RFI DS-STR-ASEC-RFI-CIVIL-003 (S-110)

PROJECT:
PROPOSED B+G+7+R HOTEL
ON PLOT NO.DIA-WE-0032(1010619),
NAKHLAT DEIRA-101,DUBAI

DRG. TITLE:
SHEAR WALL DETAILS

RFI DS-STR-ASEC-RFI-CIVIL-003

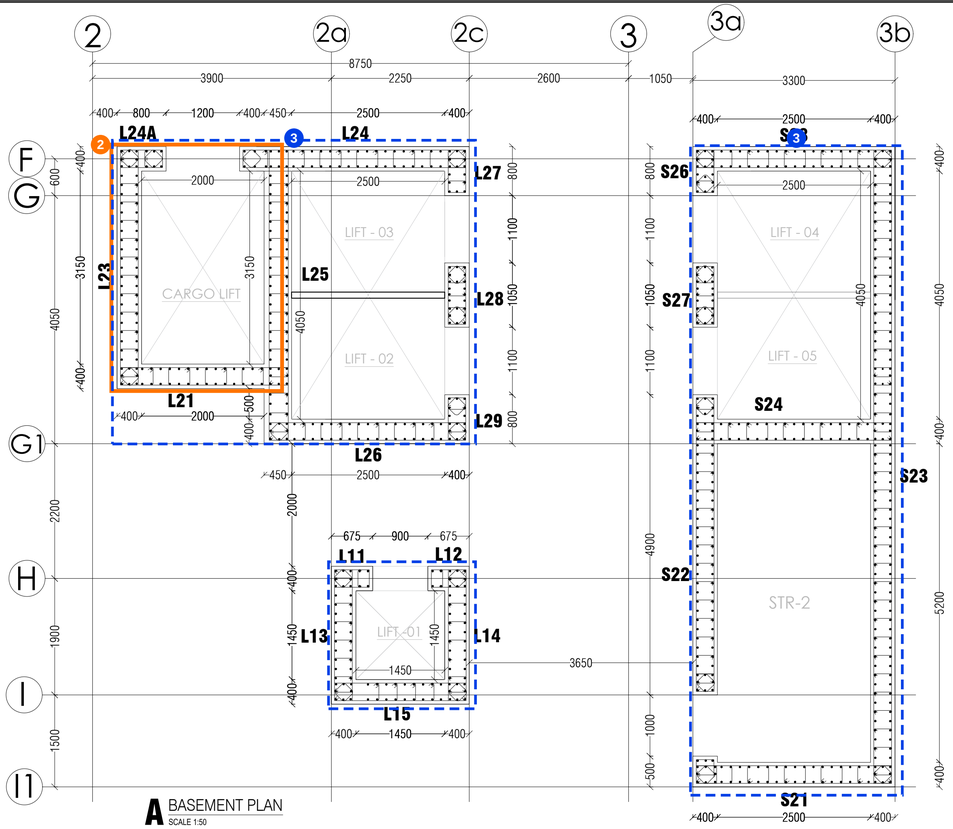
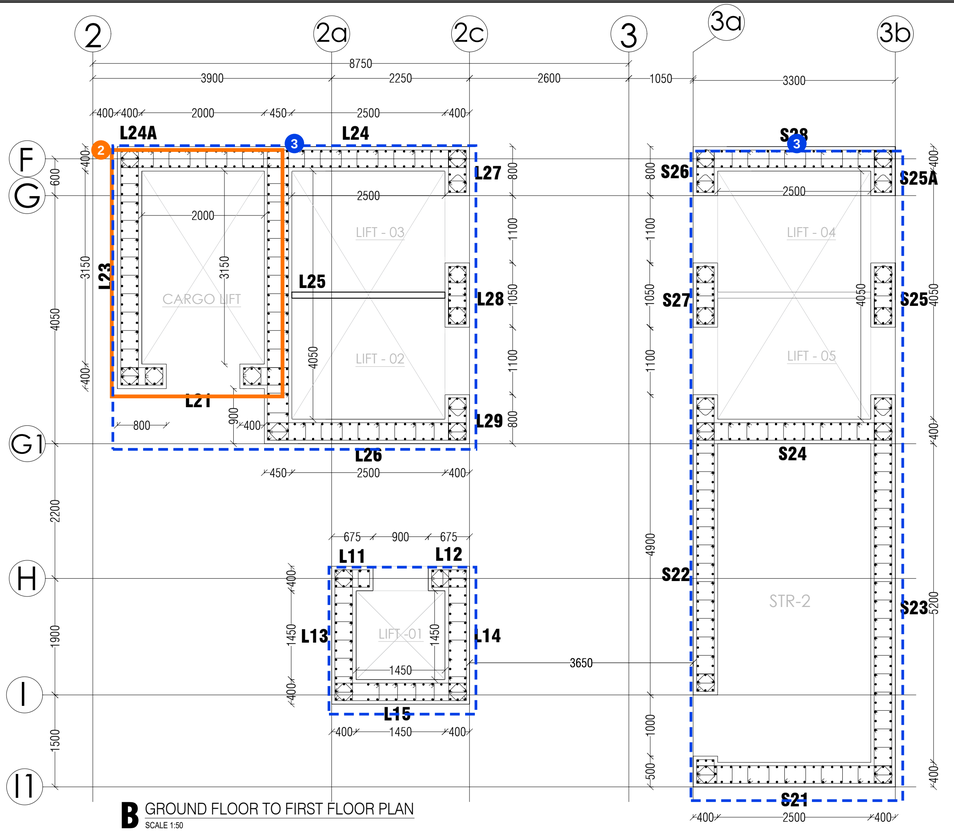
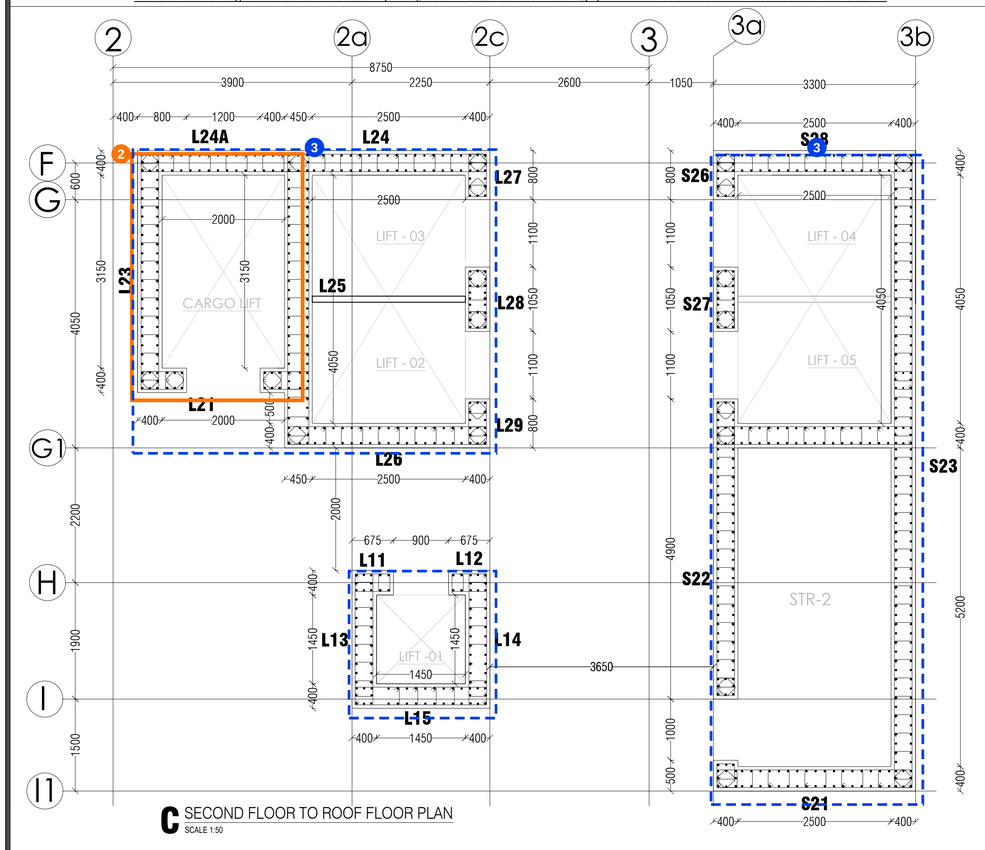
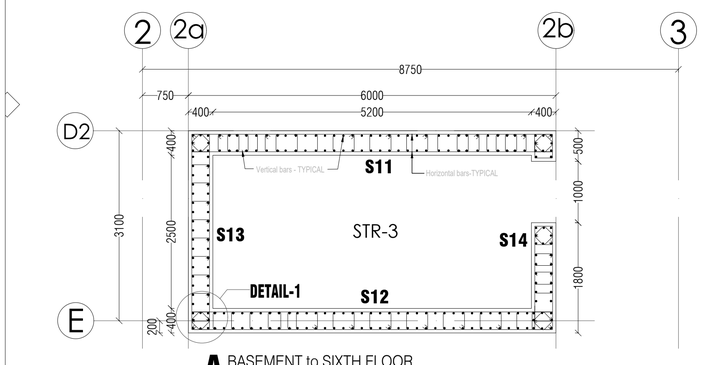
2 Cargo lift entrance does not match between sheets - full detail required for execution.

3 Lift/core walls: approval requested to proceed with casting without lift shop drawings.

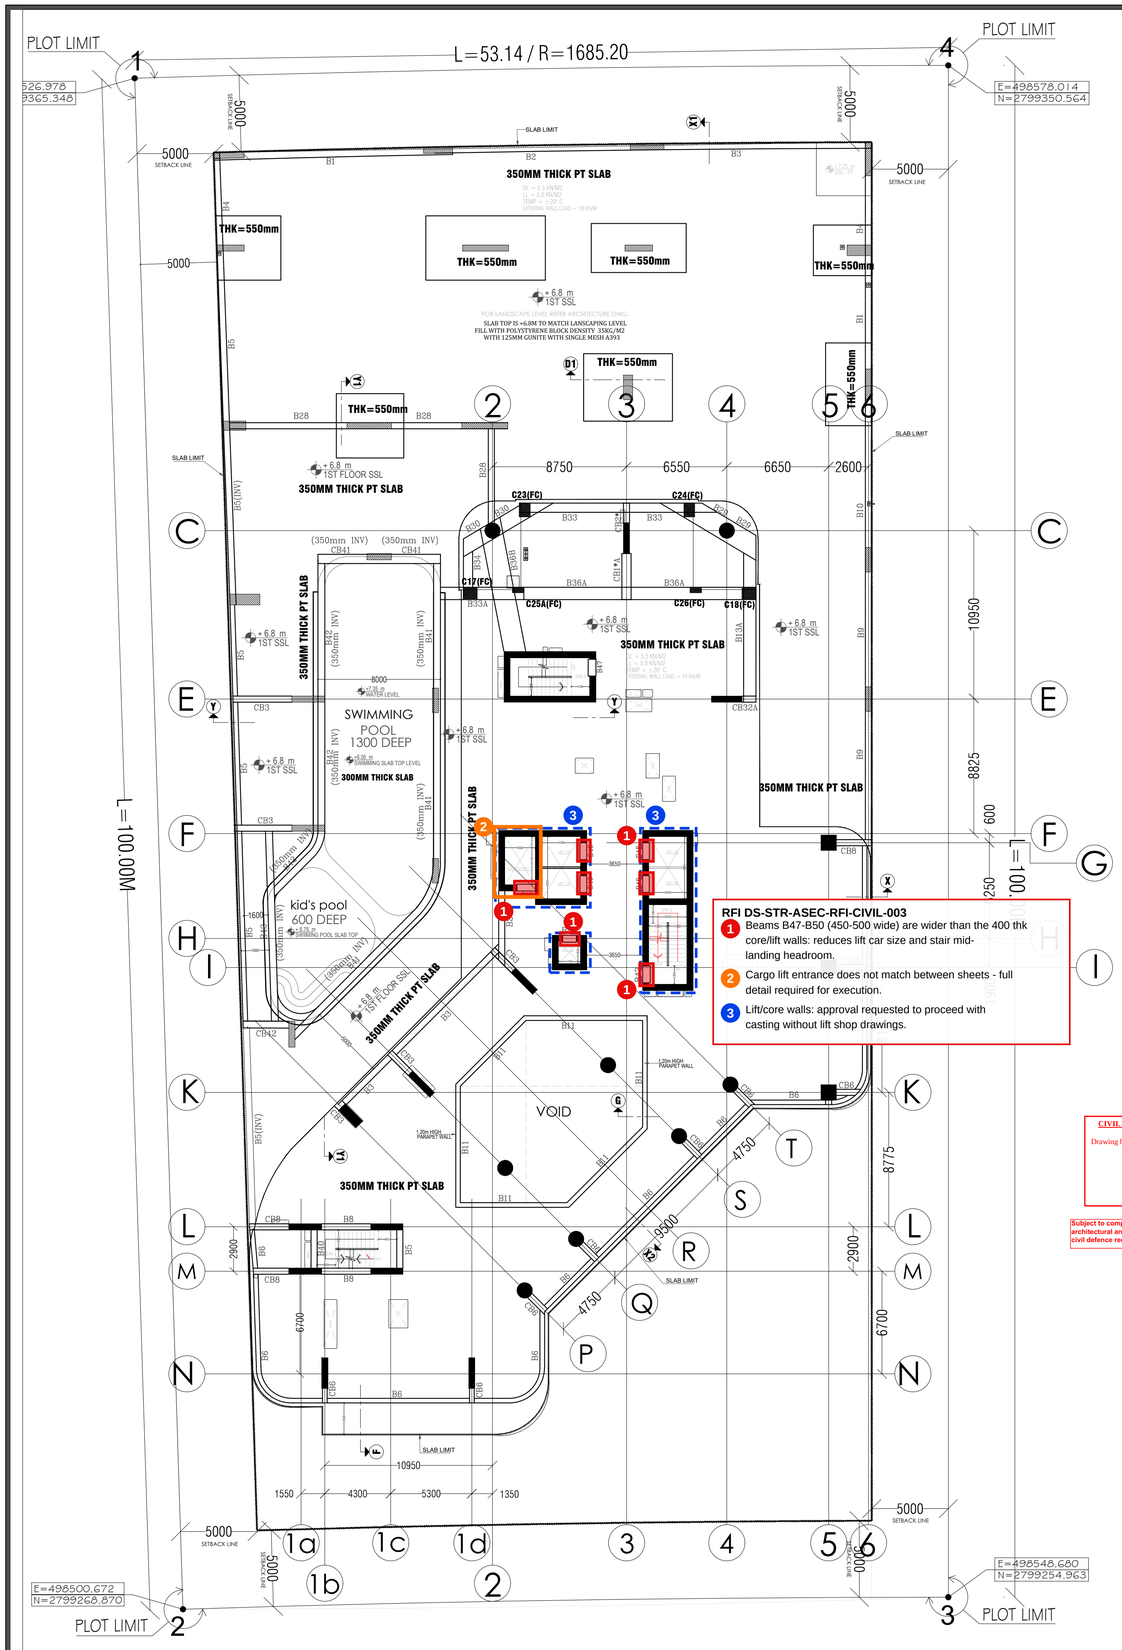
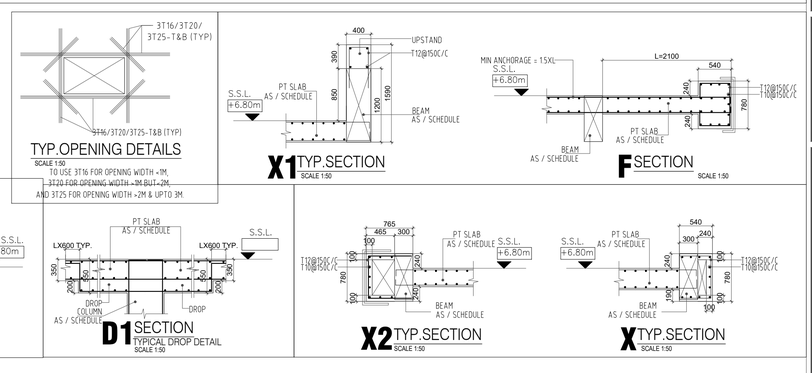
1. Beams B47-B50 (450-500 wide) are wider than the 400 thk core/lift walls: reduces lift car size and stair mid-landing headroom.
2. Cargo lift entrance does not match between sheets - full detail required for execution.
3. Lift/core walls: approval requested to proceed with casting without lift shop drawings.
